PROPOSED RESIDENTIAL DEVELOPMENT, LAND AT STONEY LANE, WHISTON – RESPONSE TO ACTIVE TRAVEL ENGLAND – MAY 2026

- 1 Eddisons have been instructed by Taylor Wimpey to advise on the traffic and transport issues relating to a planning application for the former Glen Dimplex Site in Whiston. (Planning Ref: 25/00672/FUL).
- 2 This Transport Note has been produced in response to the consultation response received from Active Travel England (ATE) dated 2nd March 2026.

DRAWING TITLE:
**PROPOSED UNCONTROLLED
CROSSING PLAN**

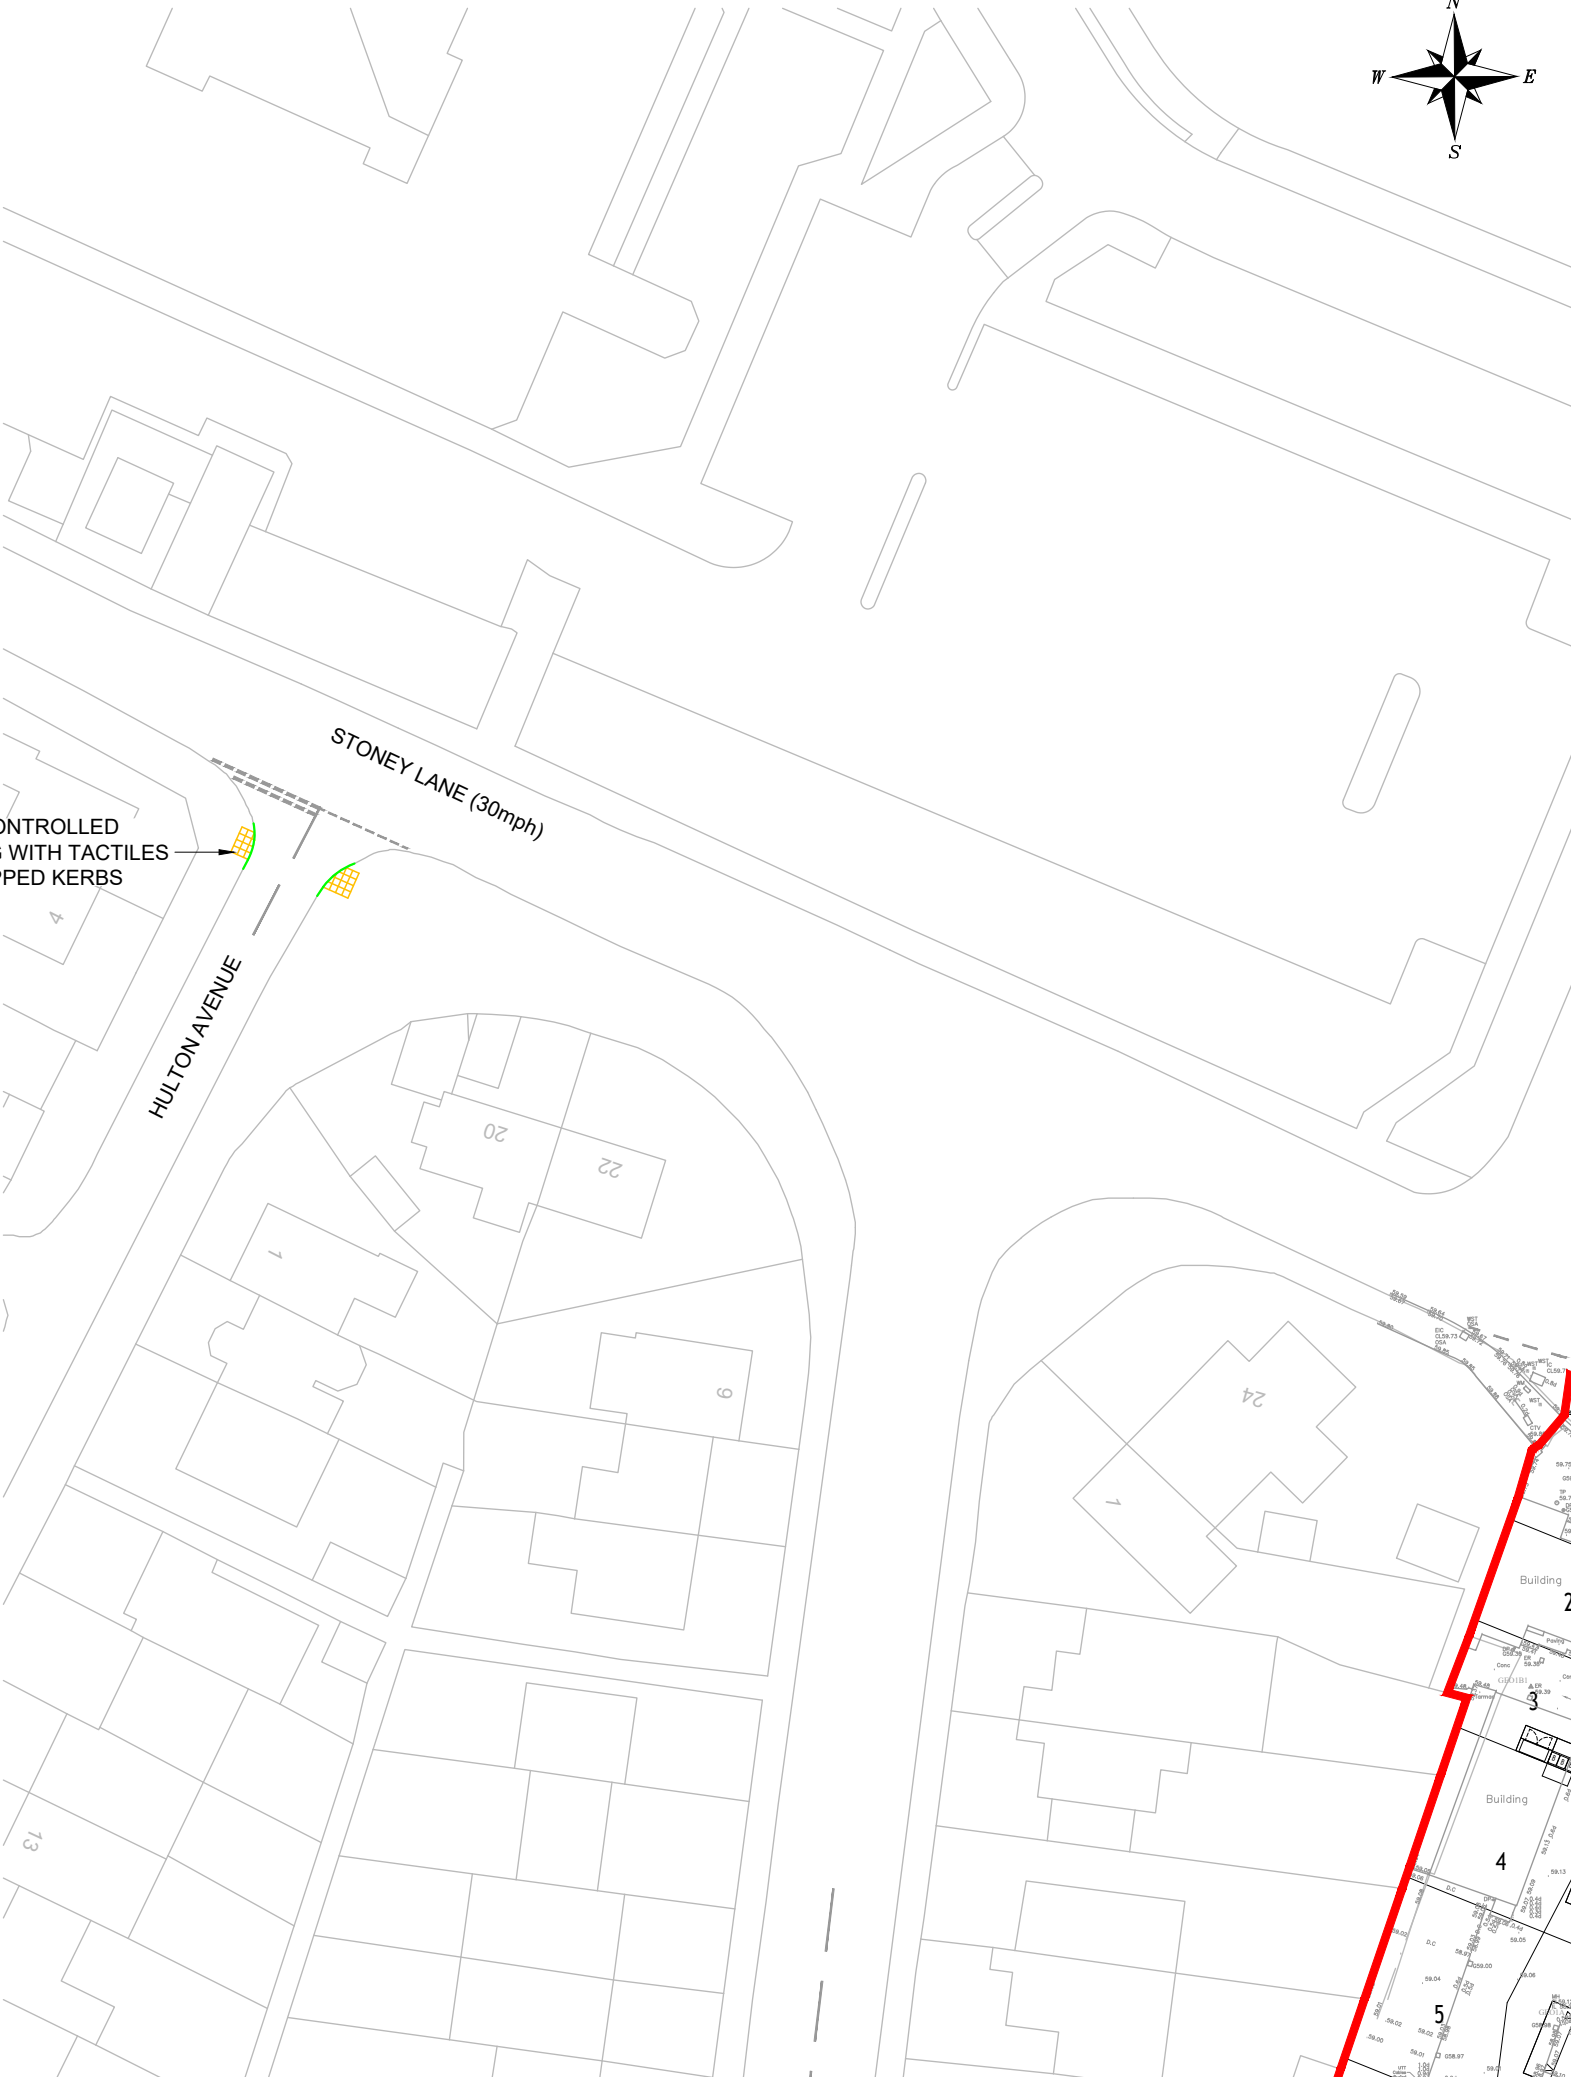
- 8 ATE has stated:
“ATE requests that the applicant clearly provides with technical drawings and images precise details of all active travel and associated infrastructure externally, including those

already proposed for the site access including the four indicative active travel only access points (DAS, p.17).

ATE also recommends that an extended active travel route audit that is experientially based with photographic evidence also takes place – this can inform the necessary improvements needed between the site and any other current and emerging active travel routes such as the various strategic active travel routes that are detailed in the recently adopted KMBC Local Cycling and Walking Infrastructure Plan (LCWIP). This is in particular reference to those that connect the proposed development to routes involving Stoney Lane and the Halsnead Village development to the south which then connect further to the East of Halewood development.”

- 9 Walking route audits to local destinations such as Whiston, Rainhill and Prescot have been undertaken. The audits assess the attractiveness, comfort, directness, safety and coherence, and identifies the potential improvements along the routes. Walking route plans have also been produced, including images of locations that could potentially be improved.
- 10 The walking route audits identified the potential improvements such as an uncontrolled pedestrian crossing with tactile paving and associated tactile paving across the Stoney Lane/Hulton Avenue priority junction.
- 11 The estimated costs for the improvement scheme at the Stoney Lane/Hulton Avenue priority junction would be between £10,000 and £15,000.
- 12 The walking route audit and associated walking route plans are provided in **Appendix 1**, whilst the proposed uncontrolled crossing plan is shown on **Plan 1**.

NEW UNCONTROLLED
CROSSING WITH TACTILES
AND DROPPED KERBS

Route 1
Proposed Site to Whiston Town Centre

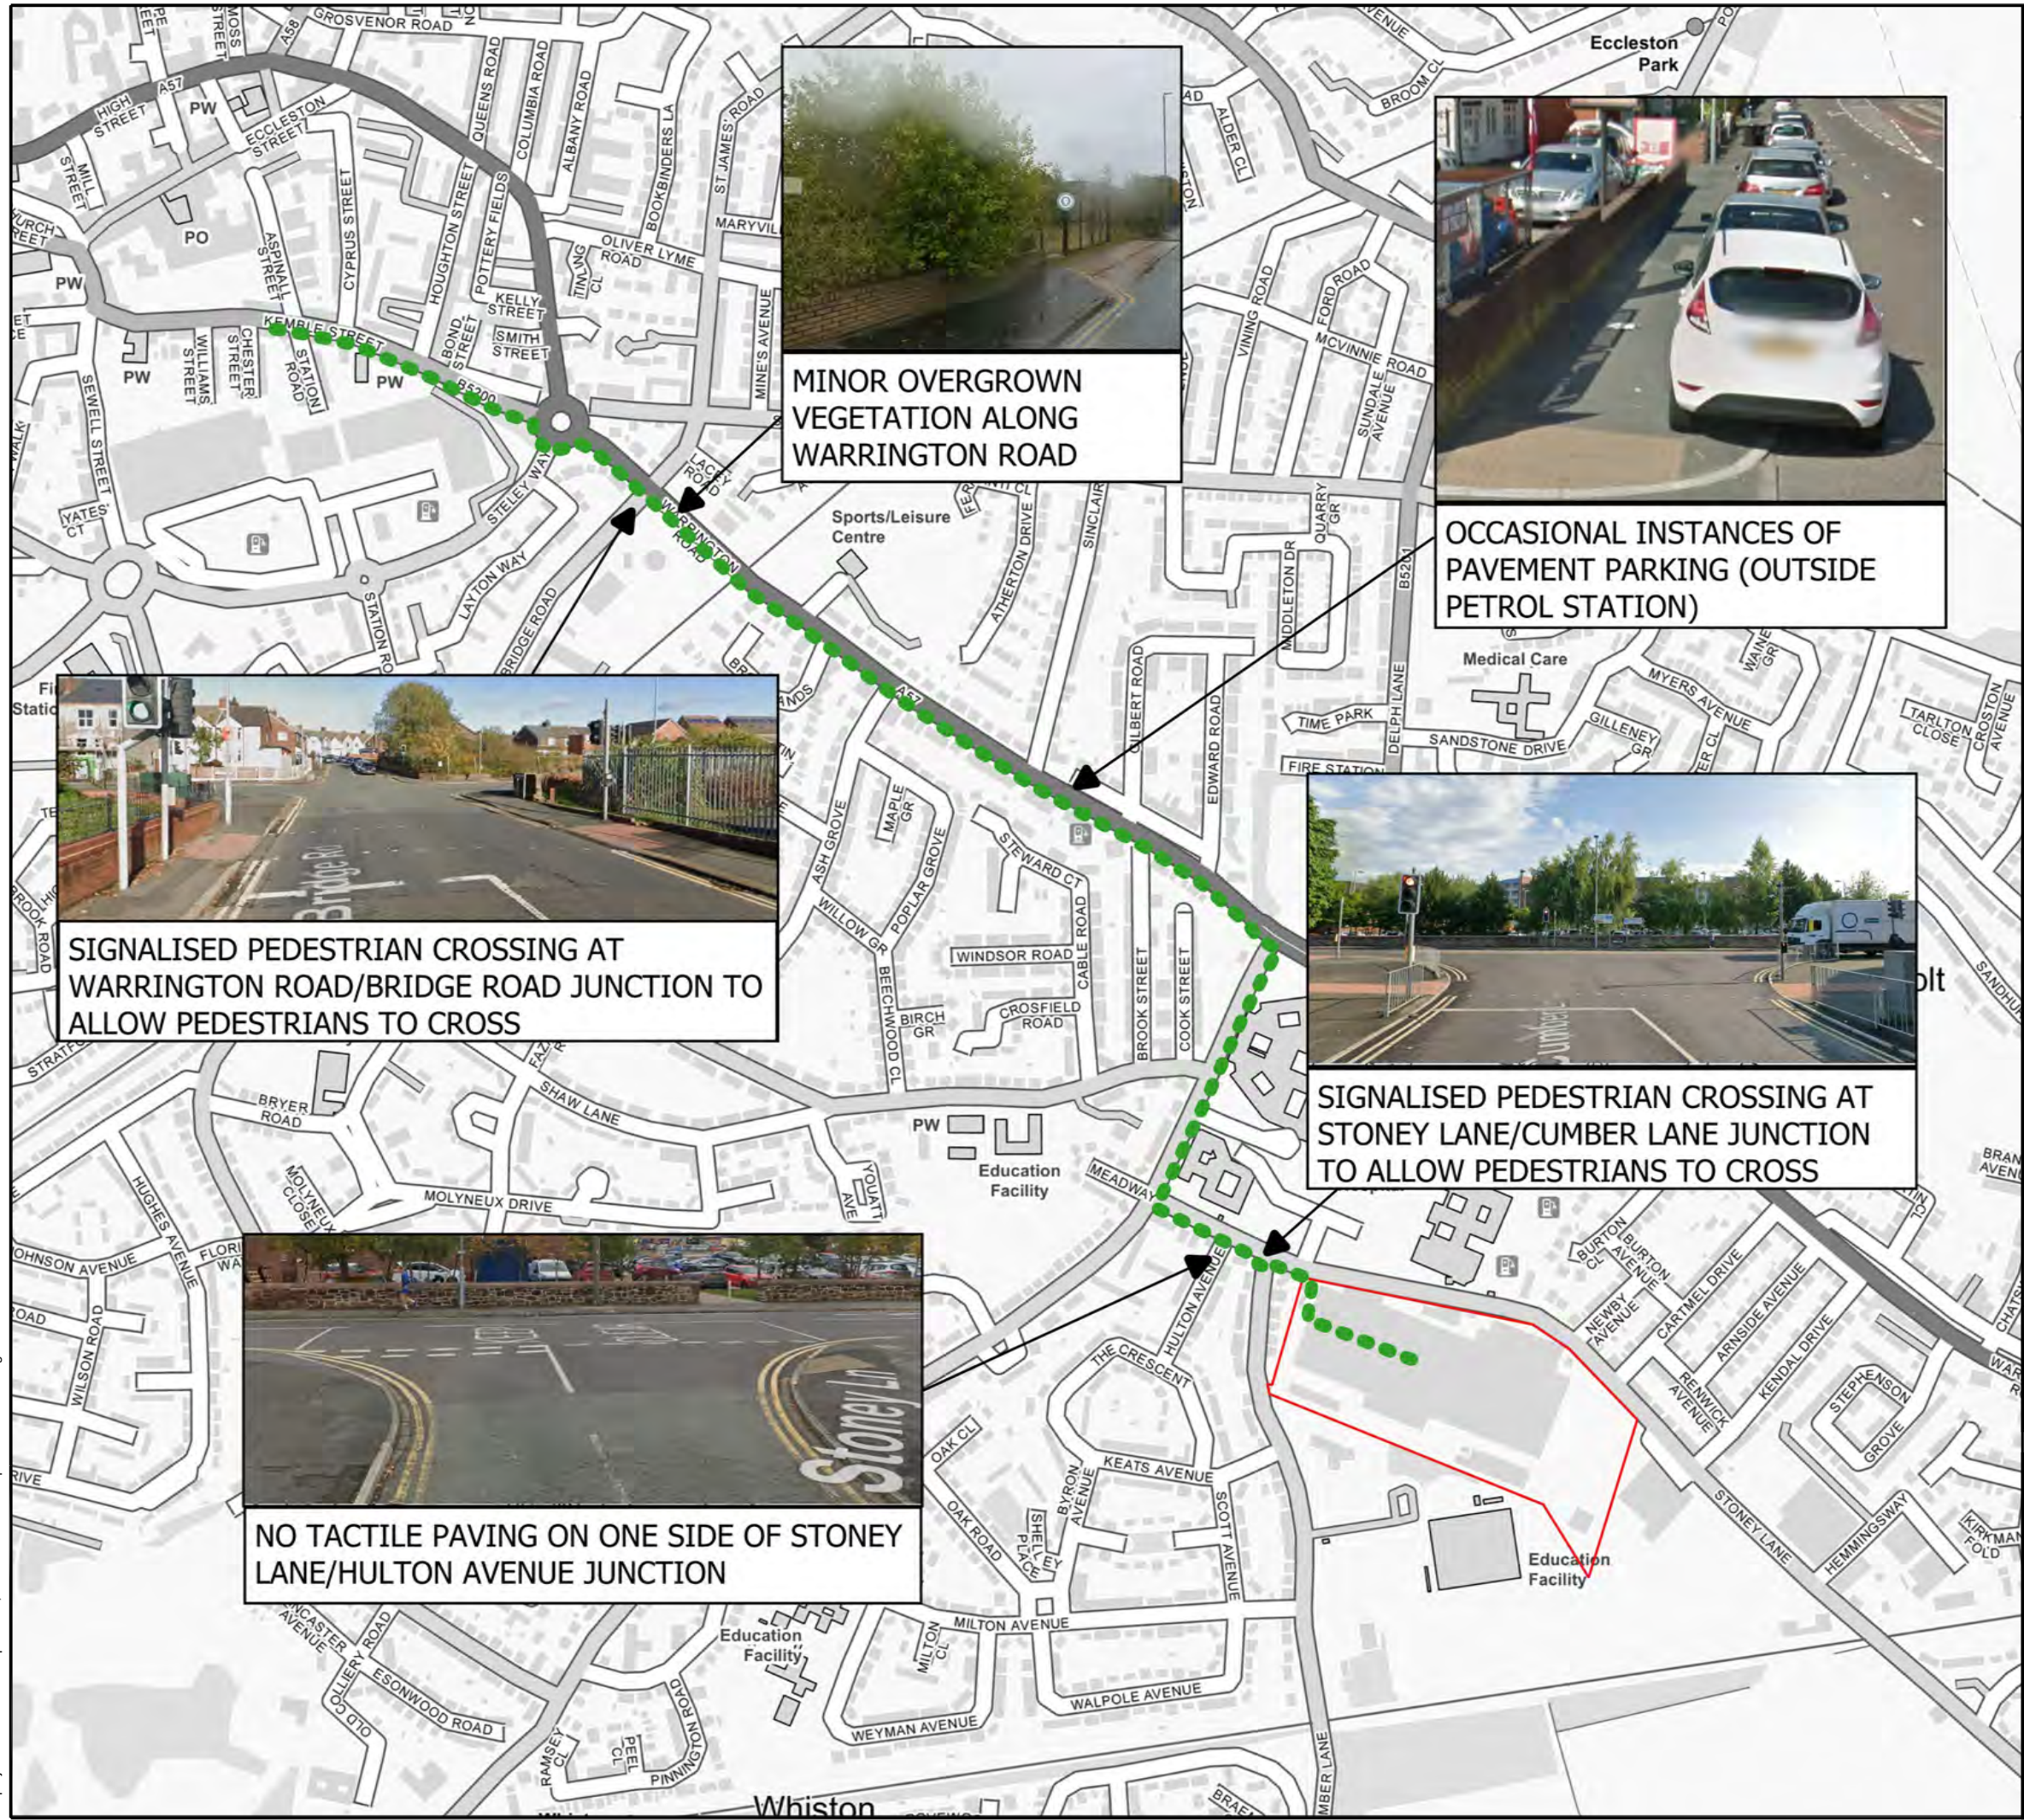
Comments	Tactile paving could be improved at some minor - low trafficked roads along the route, however, these are not considered critical as the route is considered of a sufficient quality to encourage sustainable travel to and from the site
Actions	Potential off-site improvements are to be discussed with the Council Highways at a later stage of the planning application.

Route 2

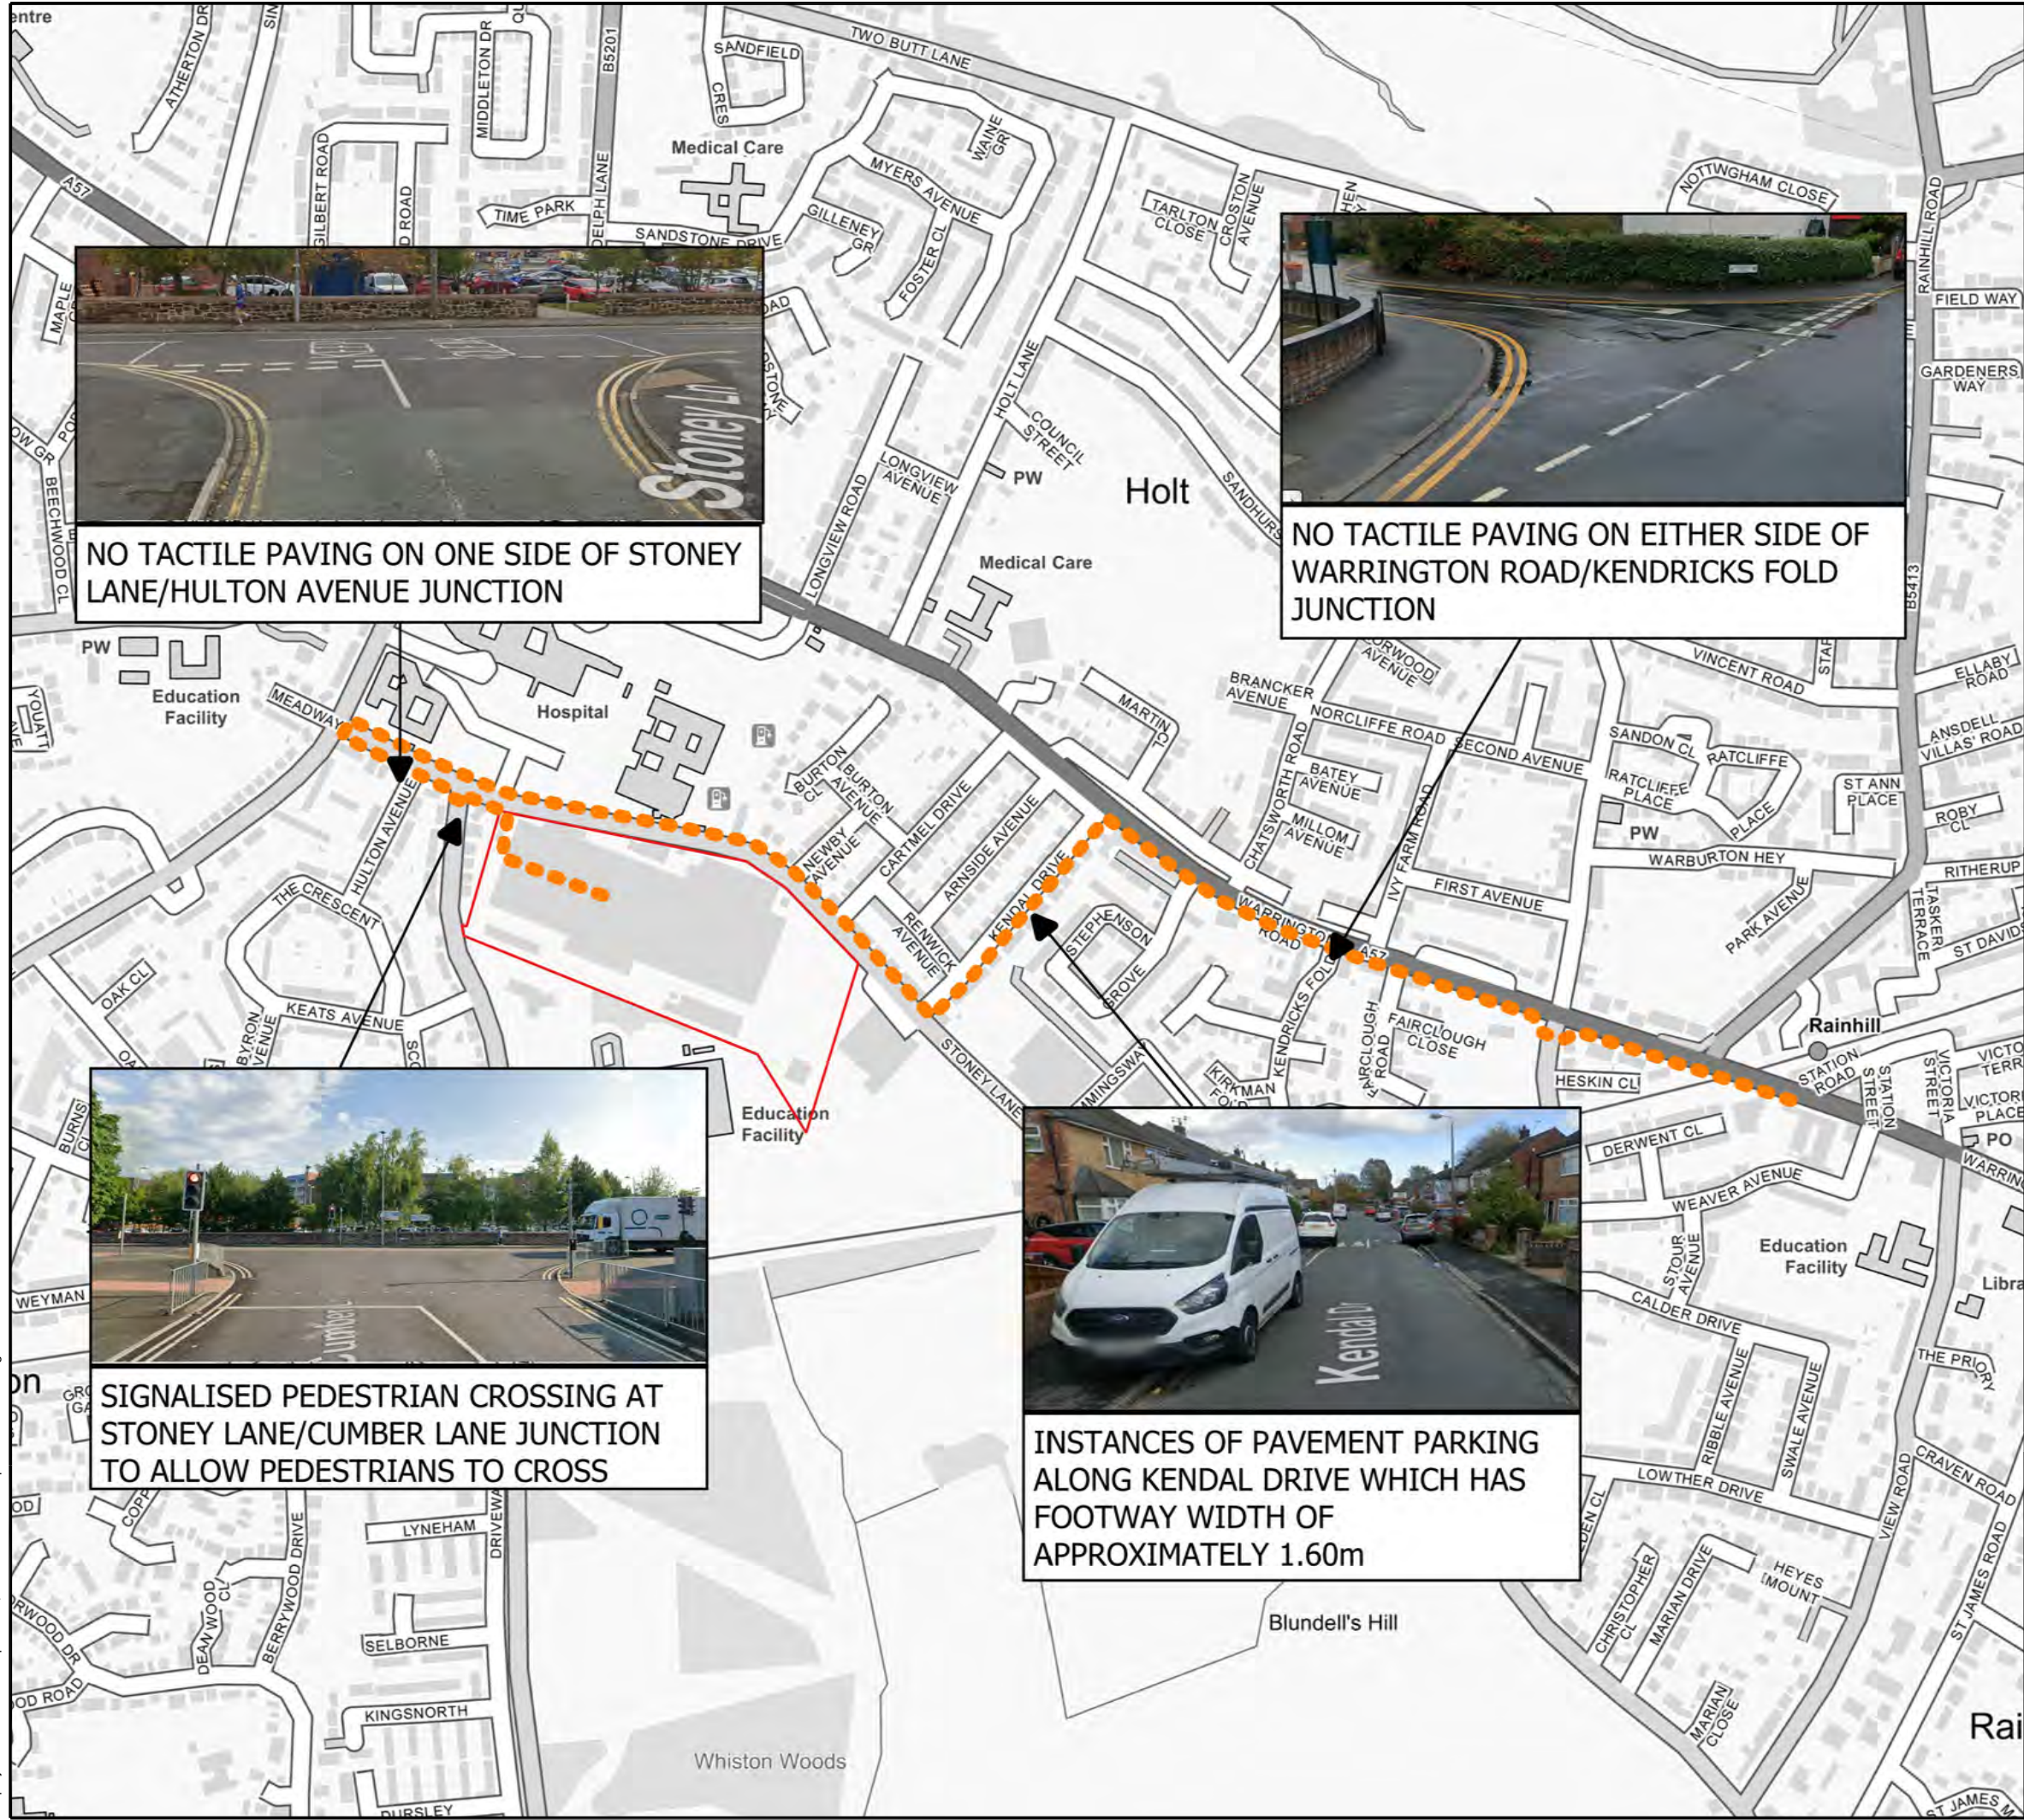
Comments	The route is generally direct and well connected, with good footway provision and crossing facilities. Whilst sections along the A57 Warrington Road experience moderate traffic and noise, this is typical of an urban environment and does not significantly impact the overall quality of the route.
Actions	No off-site improvements are proposed at this stage.
